Franklin J. Goldman, CHG

October 06, 2006

RESPONSE TO COMMENTS BY ACEHSD DATED JULY 05, 2006 RELATED TO SUBSURFACE HYDROGEOLOGIC INVESTIGATION AND GROUNDWATER MONITORING OF HYDROCARBONS AT THE FORMER DIESEL UST SITE AT THE MBM CORPORATION PROPERTY @ 5675 SUNOL BLVD., PLEASANTON, CA

Map Taken from Geraghty & Miller, Inc.
08-30-95 Figure 3
Groundwater Monitoring well MW-4
was Surveyed by Mick Lamb, certified
land surveyor, May 2006. MW-1 was
resurveyed by Lamb due to potential
perceived damage to the well box.

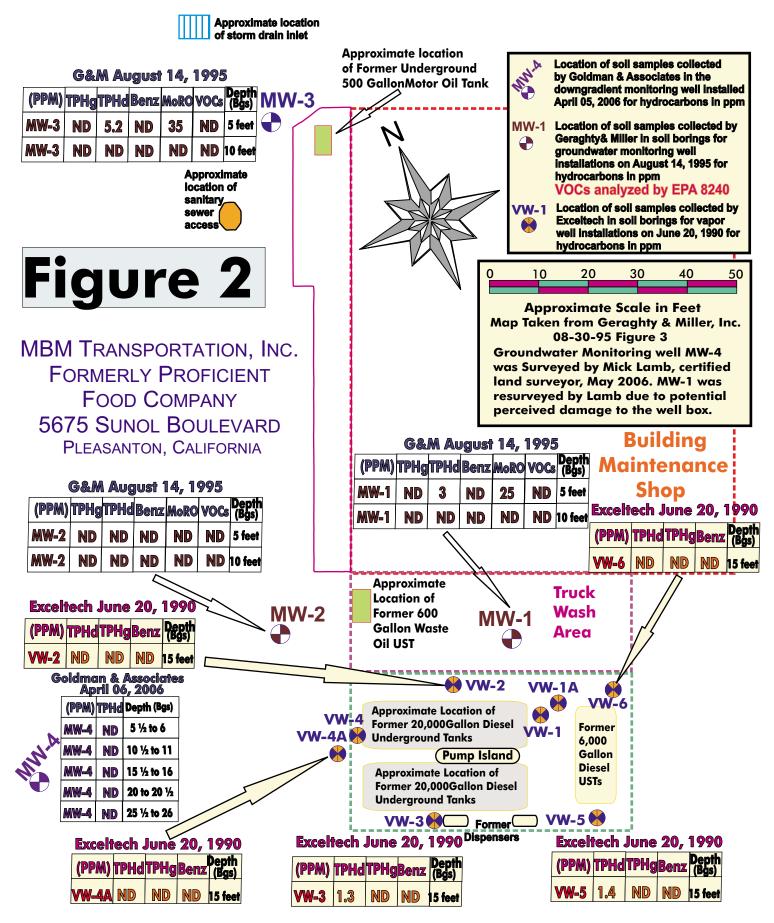
Eleven (11) years later, on April 08, 2006, the three (3) existing groundwater monitoring wells, as well as a new down gradient well, MW-4, were sampled and analyzed for TPHd, TPHg, BTEX, five oxygenates, two lead scavengers, and VOCs by EPA Method 8260b. All constituents analyzed were non-detectable (ND) in all four (4) wells. Included in the analytical list for VOCs was napthalene which was also ND. Since napthalene is used as

an indicator chemical utilized by the San Francisco Regional Water Control Board's (SFRWQCB) Environmental Screening Levels (ESLs) to determine if the presence of diesel ranged organics are a threat to sensitive receptors, the absence of napthalene in MW-4 implies that any low levels of diesel that may exist are not a significant threat to down gradient receptors (See Figure 3 for map location of the four groundwater monitoring wells along with water sample lab results).

Distribution of Diesel Ranged Organics (TPHd) & other related fuel hydrocarbons identified in soil over three (3) subsurface investigations by Exceltech (1990)[Vapor Wells], Geraghty & Miller (1995)[Groundwater Wells], & W.A. Craig (2004)[UST Pit]

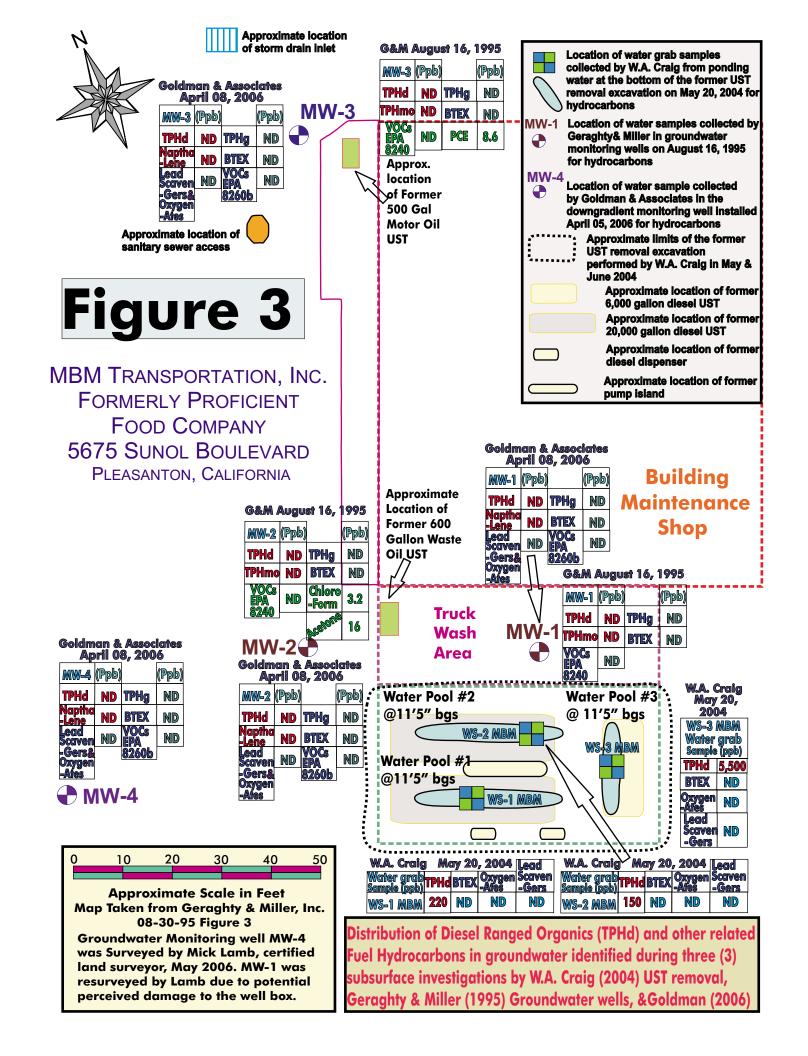
EXTENT OF DIESEL CONTAMINATION IN SOIL IN THE VICINITY OF THE FORMER DIESEL UST

A compilation of hydrocarbons in soil data has been collected in the immediate vicinity of the former diesel USTs and has been presented in map view and cross section (See Figure 1 for distribution of hydrocarbons in soil). The soil data is comprised of soil samples collected during the installation of vapor monitoring wells VW-2, VW-3, VW-4A, VW-5, & VW-6 by Exceltech in 1990, of soil samples collected during the installation of groundwater monitoring wells MW-1 and MW-2 by Geraghty and Miller in 1995, and UST pit excavation samples collected by W.A. Craig in 2004.

Over the past 11 years, soil samples have been collected from between 3 and 15 feet bgs and have yield diesel and motor oil at levels well below the 100 ppm environmental screening levels recommended by the San Francisco Regional Water Quality Control Board. In addition, hydrocarbon contaminated soil was identified on all sides and bottoms of the open UST excavation to be non-detectable prior to removal to a depth of 11.5 feet bgs by W.A.Craig, Inc. The estimated limits of the W.A. Craig UST removal pit are presented (See Figures 5a, 5b, & 5c for subsurface cross sections) based upon interpretation of soil descriptions in available soil boring logs produced by G&M and GCI. Although the exact limits of the former UST backfill soils cannot be defined, it appears that these coarse grained soils with concrete, fiberglass, and indicators observed in the field by past

WELL LOCATION MAP

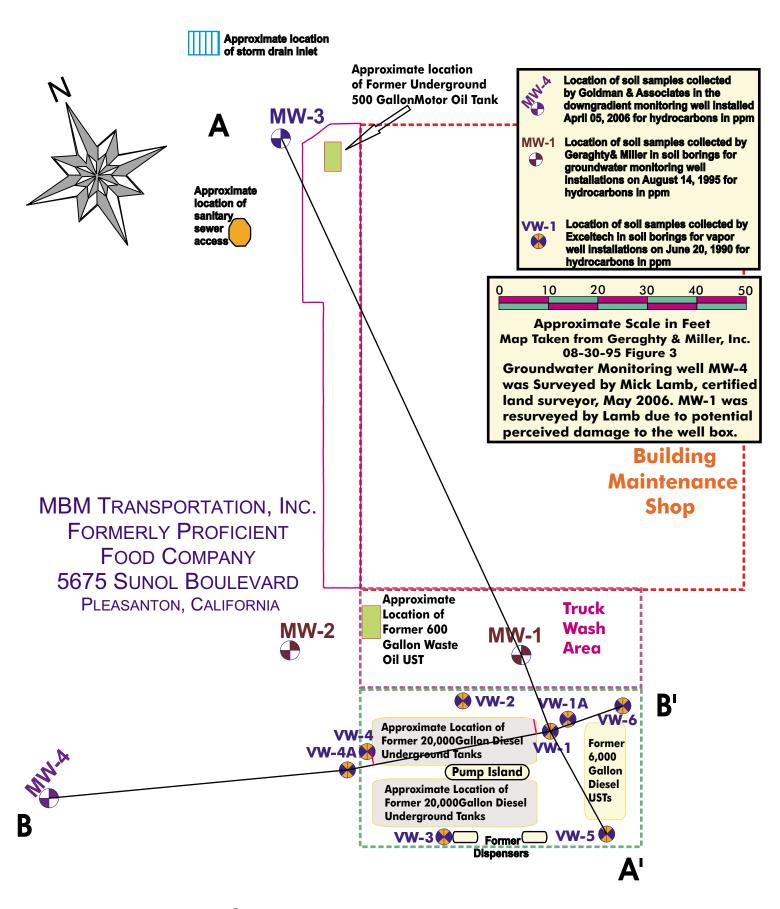
Technical Comment #6 (Response)

REVISION OF FIGURE 2 WATER SUPPLY WELL LOCATIONS AND CONSTRUCTION MAP

The water supply well map Figure 2 has been revised to include locations of domestic supply well locations obtained from State of California Department of Water Resources (DWR) Well completion reports for wells located within a ½ mile radius in addition to the supply well locations previously provided by the Zone 7 Water Agency (See Figure 6 for revised Figure 2 Supply well locations). All supply and monitoring well, well completion reports withing a one half mile radius were collected, reviewed, and evaluated. The well completion reports compiled and presented in Figure 6 of this report only include supply wells within quadrants A, B, C, G, and H of Section 29, T3S, R1E; as these are the only wells in the vicinity of the site which have the likelihood of being impacted by the contamination at the site (See Attachment D for DWR Well Completion reports).
